PUGET SOUND ENERGY PLANS FOR ANOTHER 20 YEARS OF BURNING COAL

The Sierra Club's analysis of Puget Sound Energy's 2013 integrated resource plan

Figure 2: Resource Builds by Scenario

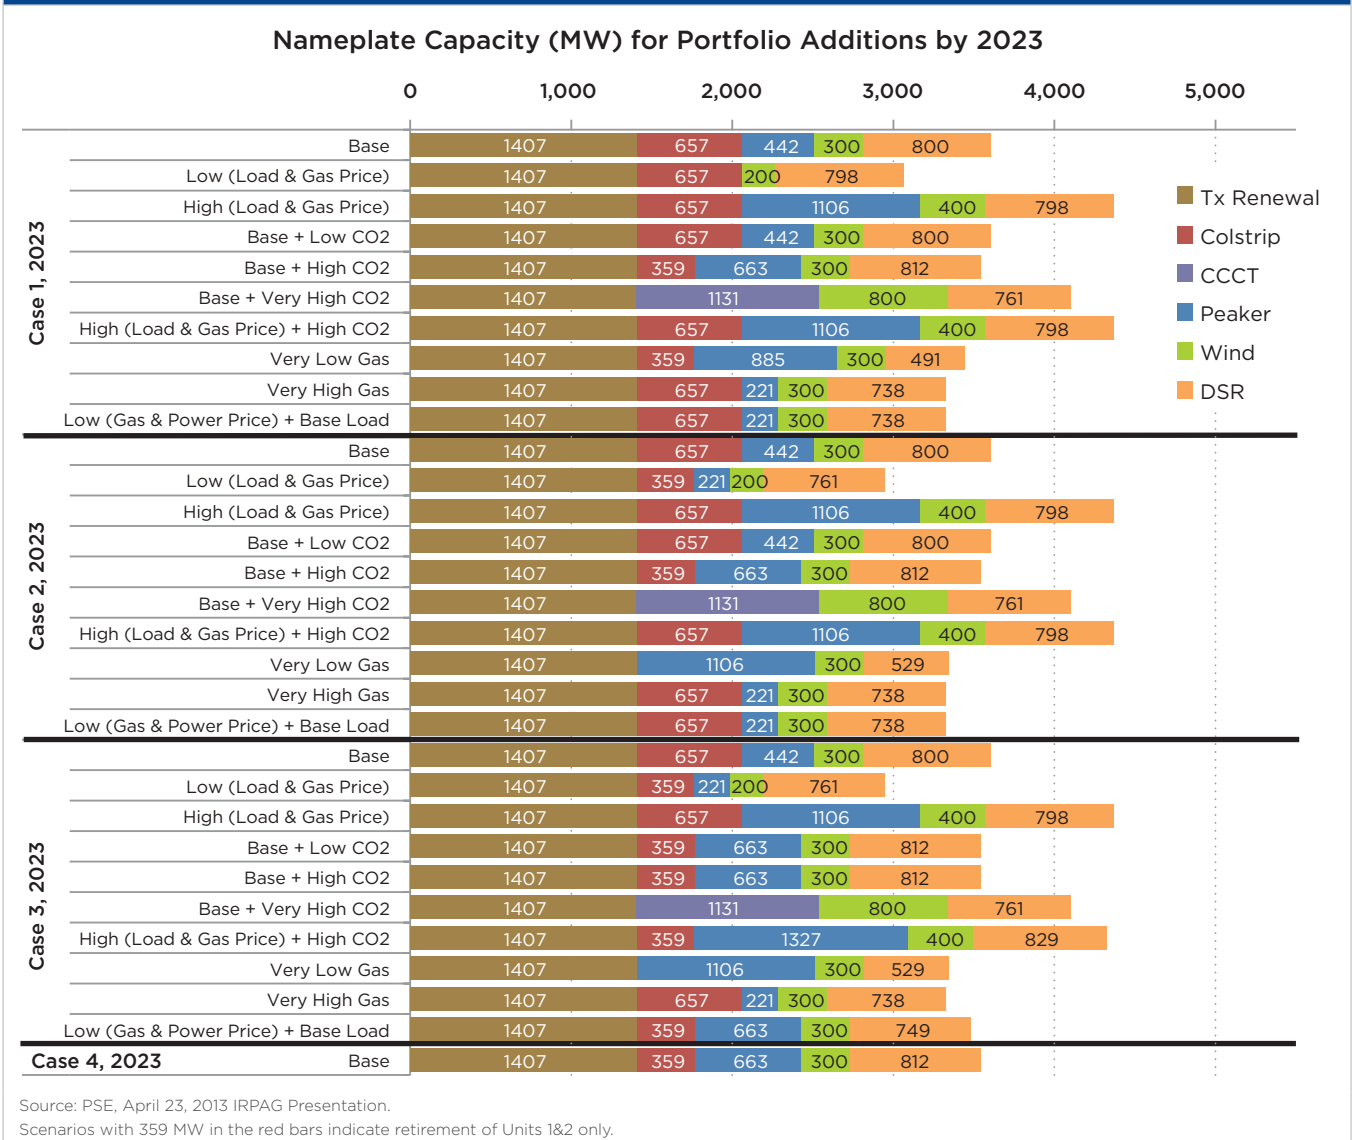
be disaggregated from the results for Units 3&4, it is clear that the results for these two pairs of units are very different. This is evident in Figure 2, below, which shows a snapshot of PSE’s expected resource mix under various scenarios in 2023. In scenarios where some or all of Colstrip retires, PSE assumed that the retirement occurred in 2017.²

The red bars in Figure 2 represent PSE’s share of Colstrip’s capacity, up to a maximum of 657 MW. If the entire 657 MW bar remains, this means that the model found it economical to continue to operate all four Colstrip units. If only a 359 MW red bar is shown, then the model replaced Colstrip Units 1&2 in 2017. If there is no red bar for Colstrip, then the model replaced all four Colstrip units in 2017. Figure 2 shows that it is more economical to replace Units 1&2 in a large proportion of the scenarios (15 out of 31). Units 3&4 are also replaced under very low gas prices or very high

CO₂ prices.³ Figure 2 shows that the relative economic costs and benefits of Colstrip are very different between Units 1&2 and Units 3&4.

Figure 3: Annual Revenue Requirement in Base Scenario

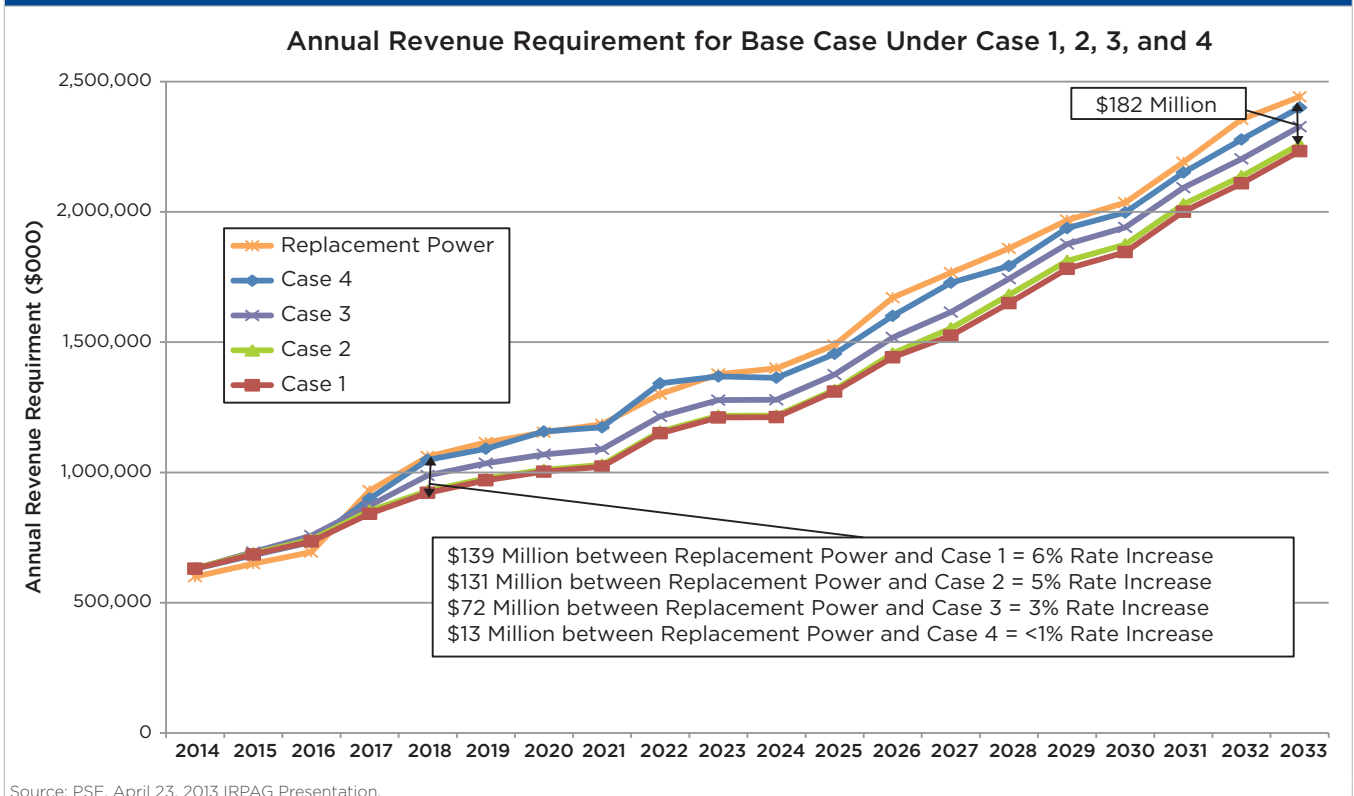
The results presented by PSE in Figure 3 show only the overly-conservative "Base" scenario. Figure 3, and PSE's conclusions based on this figure, are therefore biased in favor of retaining Colstrip. In reality, it is very unlikely that PSE will face a \$0 cost for CO₂. The rate impacts shown in Figure 3 are therefore higher than what would plausibly be expected, and a more realistic analysis would reduce or even eliminate the cost of replacing all four Colstrip units. In scenarios other than the Base scenario, PSE's analysis shows that natural gas prices, CO₂ prices, and investment in Demand-Side Resources (DSR) have significant impacts on the relative economics of Colstrip:
